| Model: QU-D1 | Date: 12-Aug-16 | No.: RC284001 |

| Subject: Firmware Release Note: Main                         |   | Prepared by: A. Ishida  |   |

| Subject: Cloth screen of drum is torn               |  | Prepared by: K.Yamamoto   |  |

| Subject: Image problem due to shift (Slip out position) cloth screen |  | Prepared by: K.Yamamoto   |  |

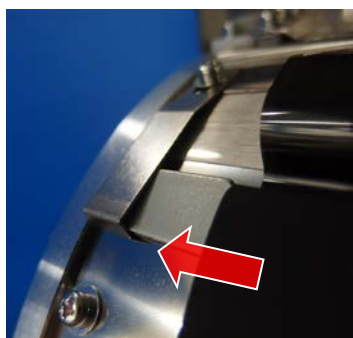
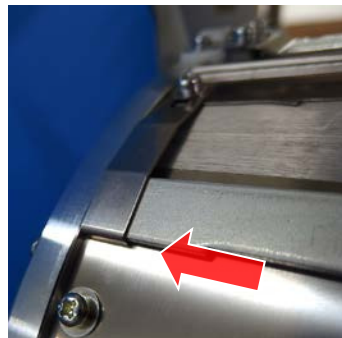
- The new hook features a corrected angle, as shown.

**C2842276**

[Old]

2 bending parts

**C2842277**

[New]

3 bending parts

| Old part number | New part number | Description               | Q'ty | Int | Note         |
|-----------------|-----------------|---------------------------|------|-----|--------------|
| C2842276        | C2842277        | DP:R8-A1522:ANGLE         | 2    | X/O | Common       |

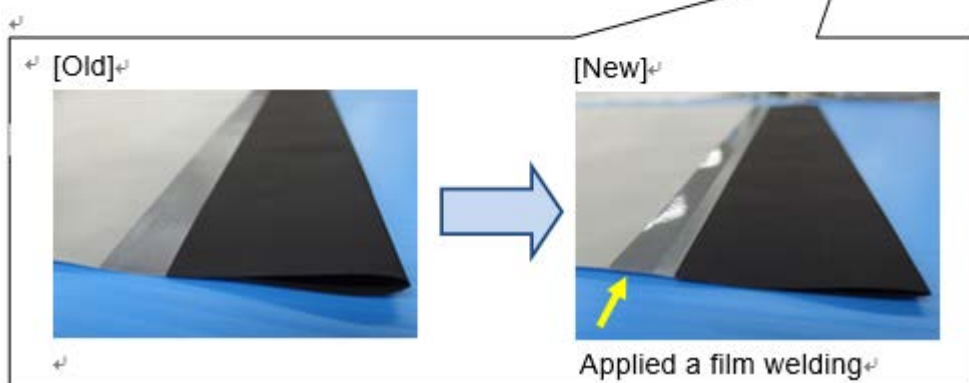
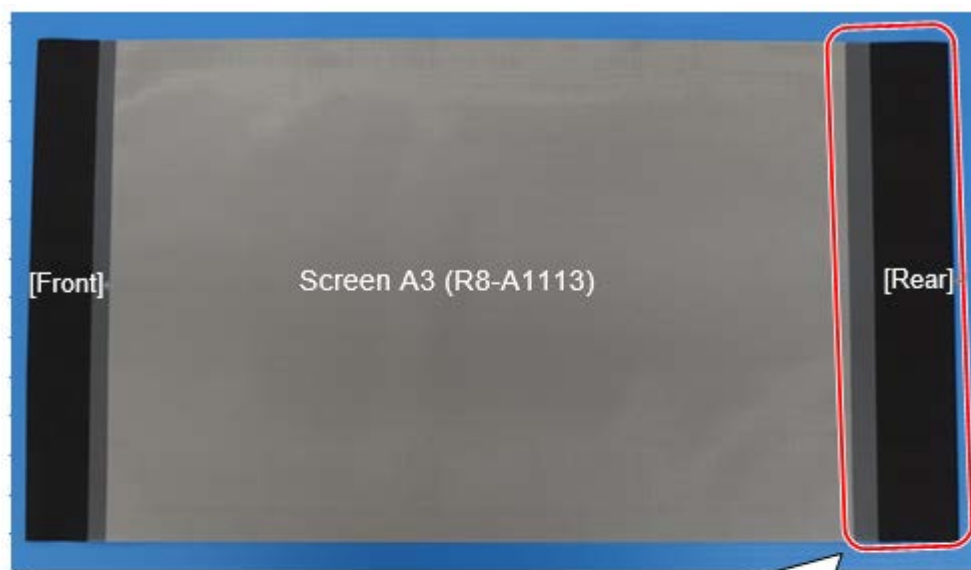
Ink leaks from the drum.

The edge of the cloth screen contacts the drum guide during printing, causing it to tear.

Replace the cloth screen with the new part.

| Old part number | New part number | Description           | Q'ty | Int | Note         |
|-----------------|-----------------|-----------------------|------|-----|--------------|
| C2842261        | C2842245        | DP:R8-A1113:SCREEN:A3 | 1    | X/O | For A3 Model |
| C2832261        | C2832245        | DP:R8-A1213:SCREEN:B4 | 1    | X/O | For B4 Model |
